SUBJECT: Provides response to request for addl info re topical rept  
           NTH-TR-01, "RETRAN Model Qualification - Decrease in Heat  
           Removal by Secondary Sys."

Subject: Response to Request for Additional Information  
Related to Topical Report NTH-TR-01, RETRAN Model  
Qualification - St. Lucie Plant Unit Nos. 1 and 2  
and Turkey Point Plant Unit Nos. 3 and 4 (TAC Nos. M75082,  
M75083, M75084 and M75085)

FIGURE 1. TURKEY POINT, RETRAN MULTINODE STEAM GENERATOR MODEL

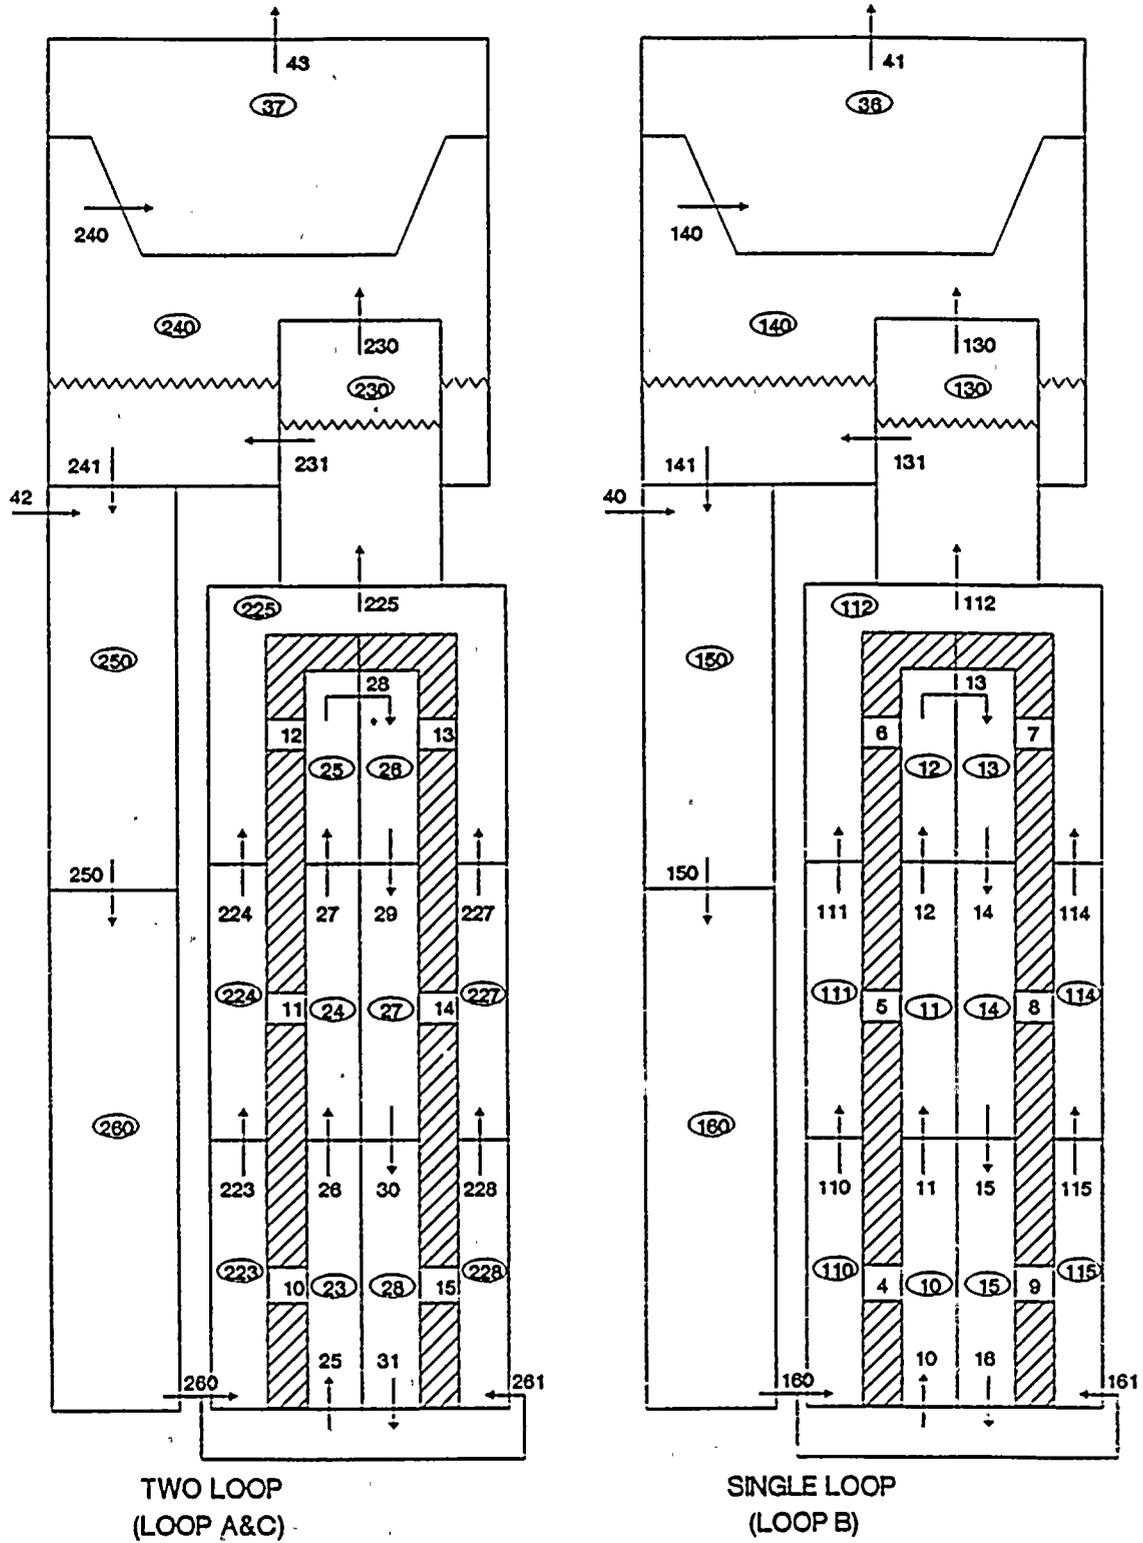
QUESTION # 1: Qualify and discuss Single Node SG model performance for applicable transients (Turkey Point and St. Lucie).

QUESTION # 2: Evaluate nodalization sensitivities regarding multi-node SG modeling.

The two regions in the steam generator model (Figure 1) most likely to be impacted by a more detailed nodalization are the downcomer and the tube bundle regions. In particular, the lower tube bundle region is where the colder feedwater/auxiliary feedwater begins absorbing heat from the primary side. A finer nodalization will allow a better representation of the heat transfer process taking place in this region. A more detailed nodalization of the downcomer region has been considered to be of lesser impact, especially if the Temperature Transport Delay code option is used.

Based on the above arguments, a new MNSG model was prepared in which each of the lower two tube bundle volumes and heat conductors was split into two equal volumes and heat conductors, respectively. This corresponds to volumes 110 and 115 and conductors 4 and 9 for the Single Loop steam generator model (see Figure 1).

The basis for this change is that by eliminating phase separation in the volume that represents the actual separator (volumes 130 and 230 in Figure 1), the typical uncertainty associated with separator modeling is removed.

The two parallel volume stacks in the tube bundle of the current MNSG model (Figure 1) have been combined into a single stack. Although the two-stack approach is justifiable in terms of the little mixing between the two sides of the tube bundle (Reference 7), this sensitivity study has been selected to investigate any possible differences between the two approaches.
